From: [Redacted]
Sent: 19 October 2023 11:46
To: [Redacted]
Cc: [Redacted]
Subject: RE: St John Road Trail - Road Humps

From: [Redacted]@gov.je>
Sent: Thursday, October 19, 2023 11:58 AM
To: [Redacted]2@gov.je>; [Redacted]@gov.je>
Subject: St. Johns Rd/Parade Road - Humps

Not sure if we should extend Hump 2 for the full carriageway width. It currently matches the detail of Hump 1.

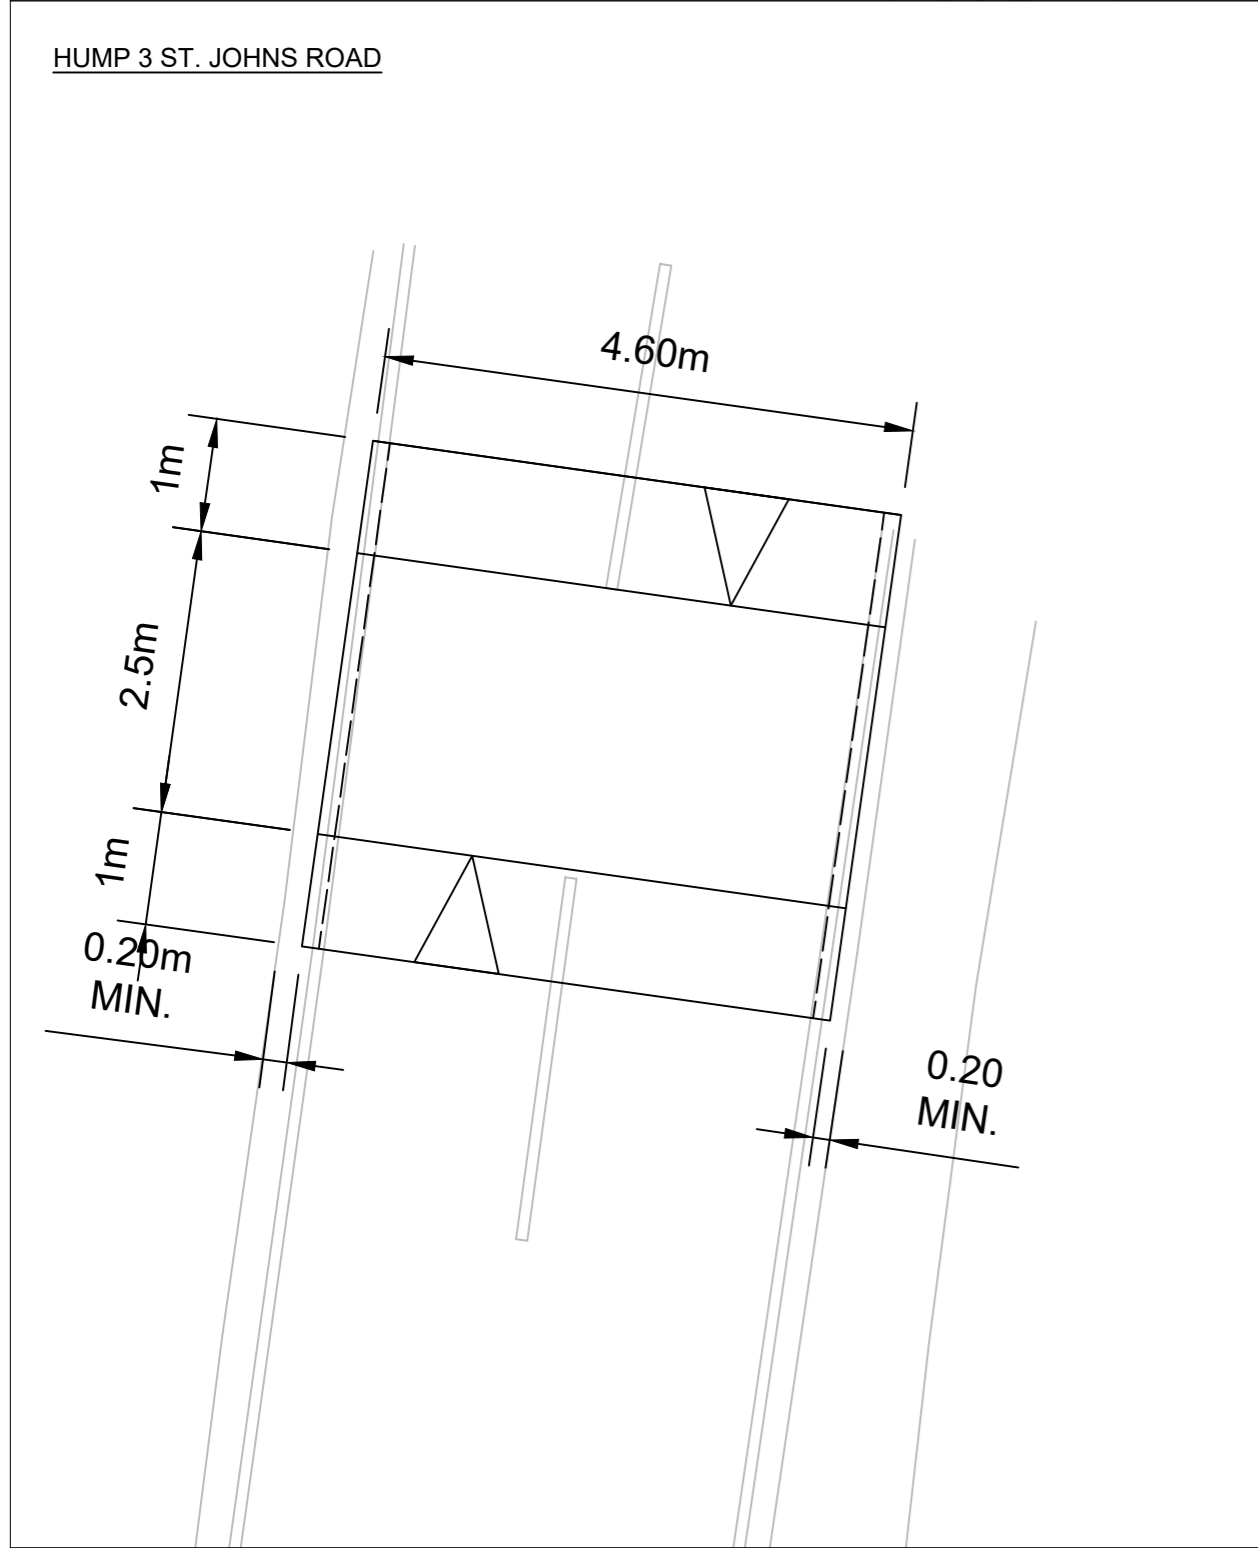
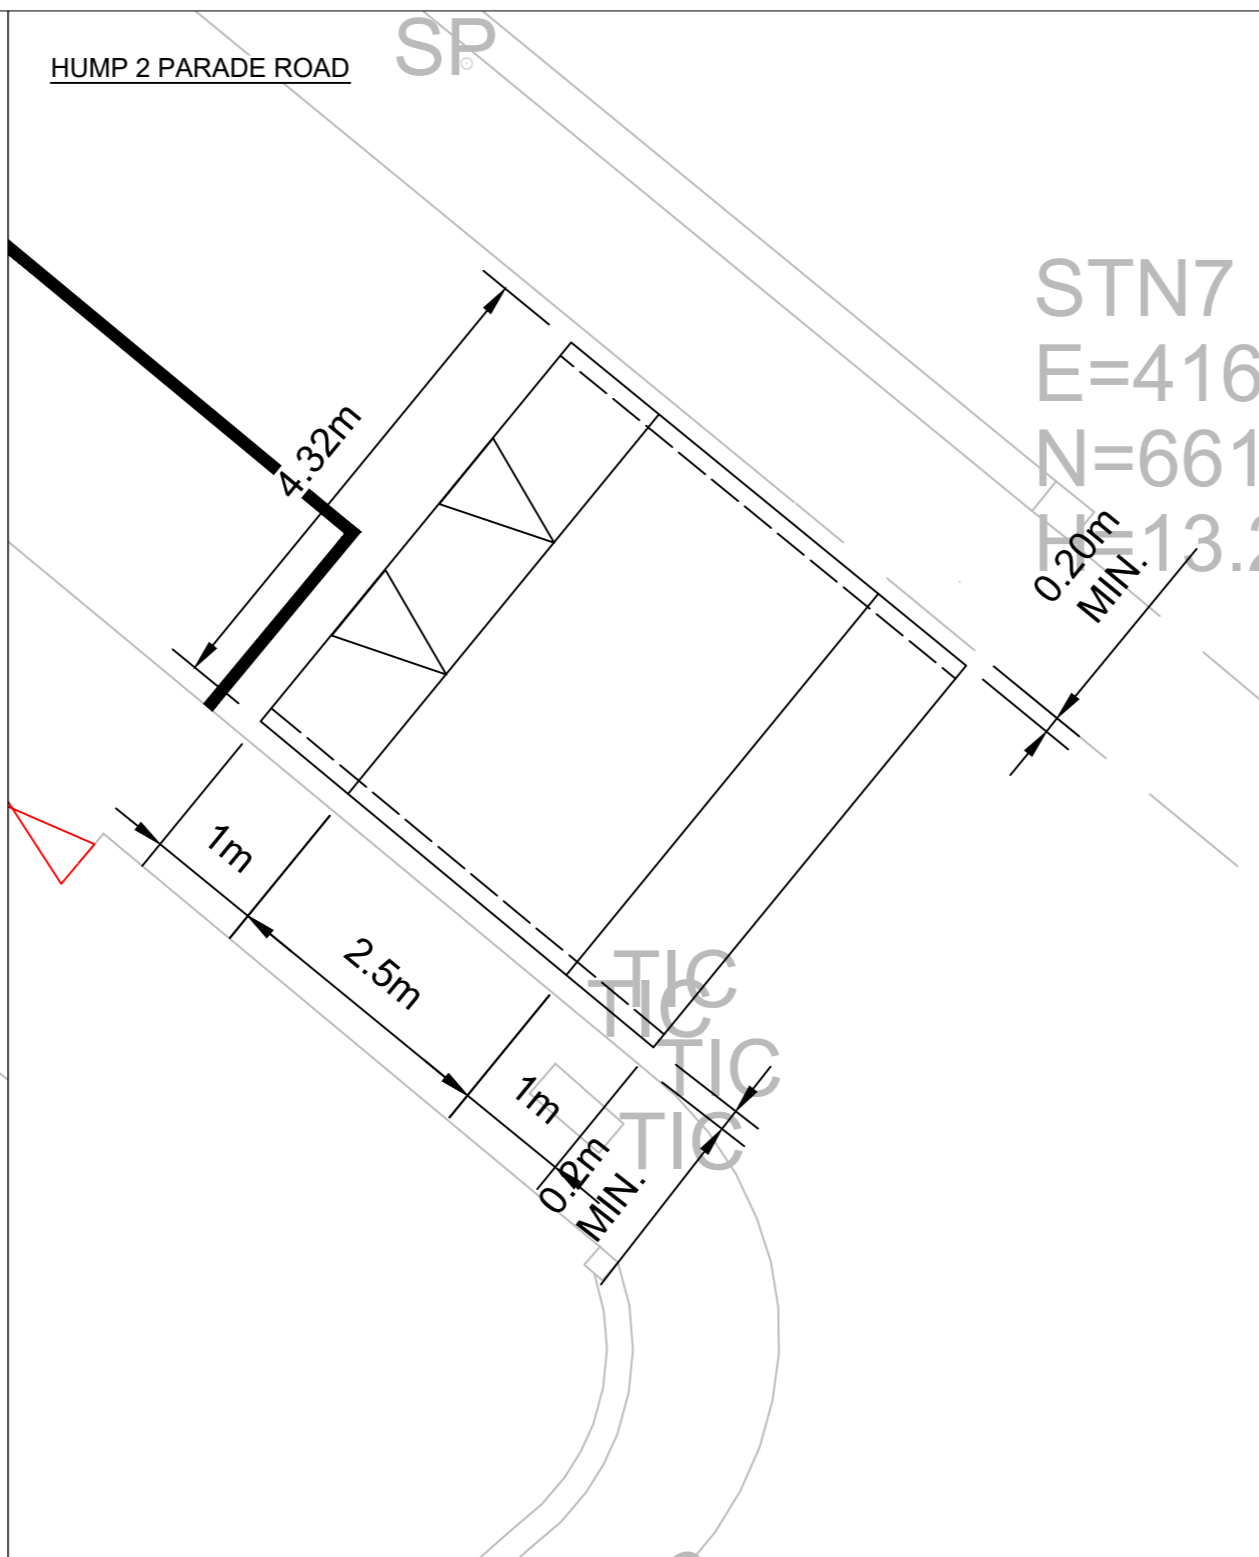
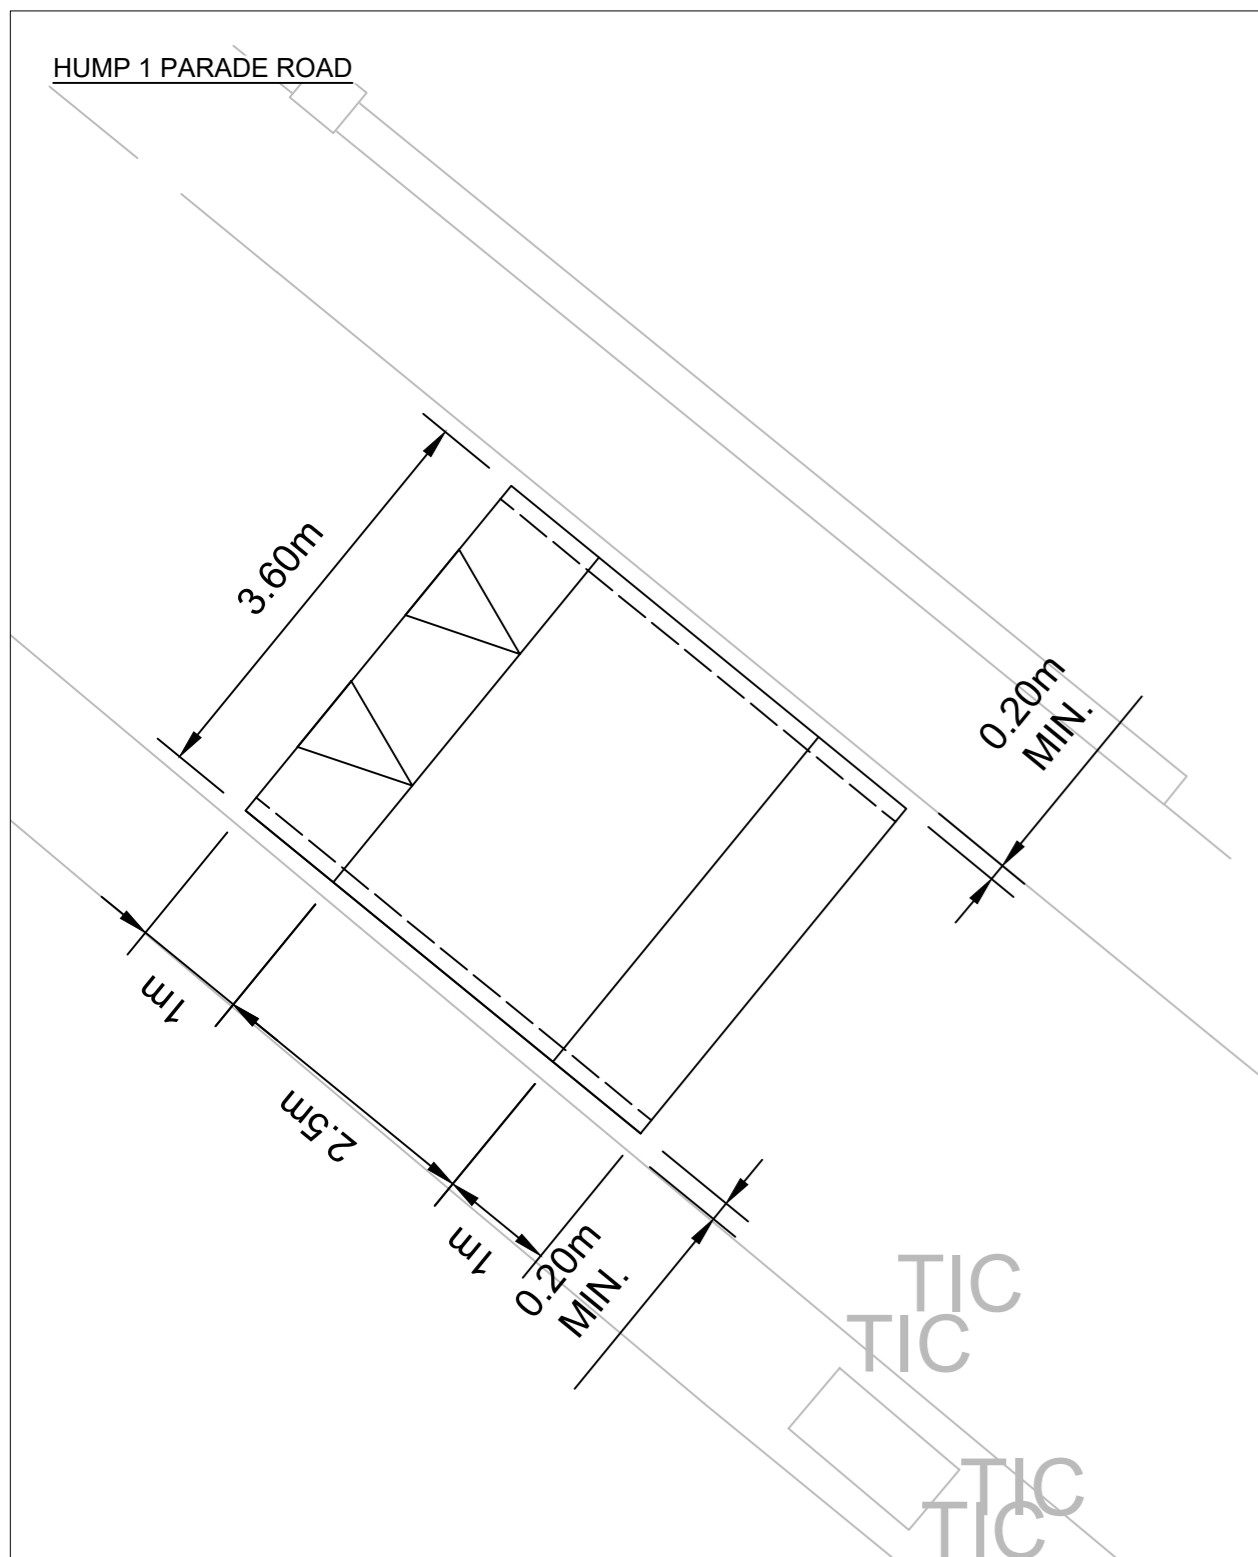
As I understand the law requires the speed table/hump to be kerb to kerb so for all three locations we need to allow for that(minus the drainage channel as allowed-200mm).

Looks better now. I am waiting for response back from one of the suppliers and will ask them to match their supply to our requirements.

Amended as below.

Diagram 3. Flat Top Hump

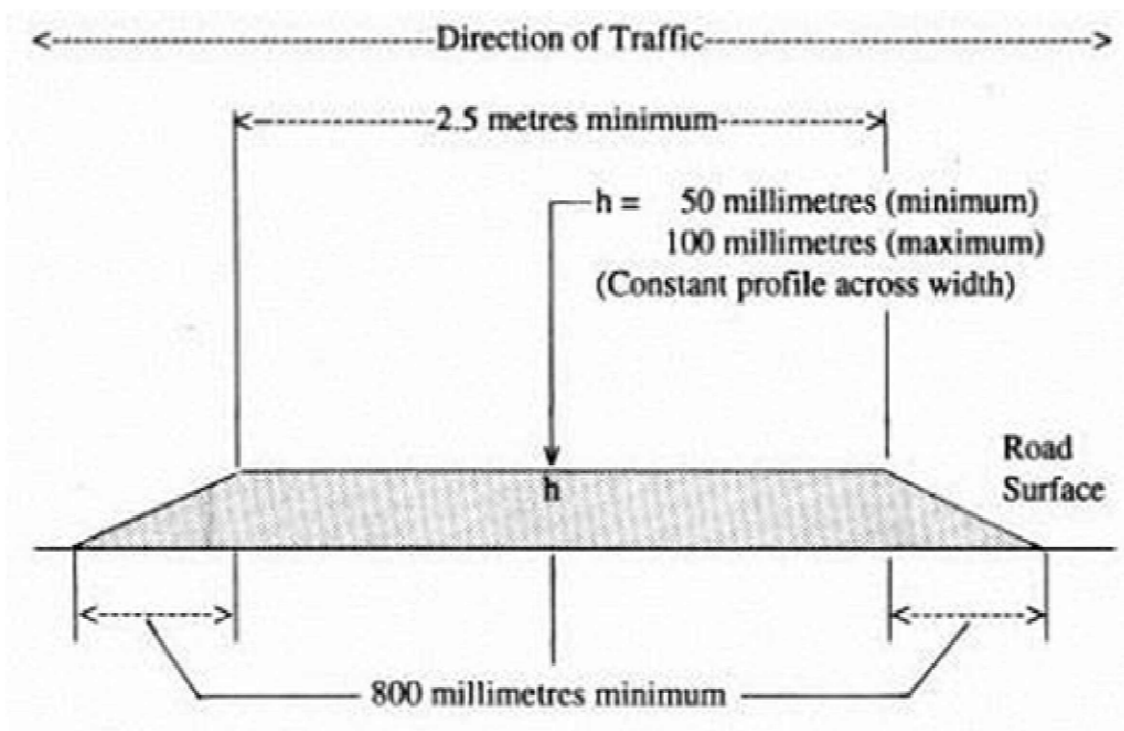
This hump normally extends across the highway from kerb to kerb.

A permitted variant is given in diagram 4a below.
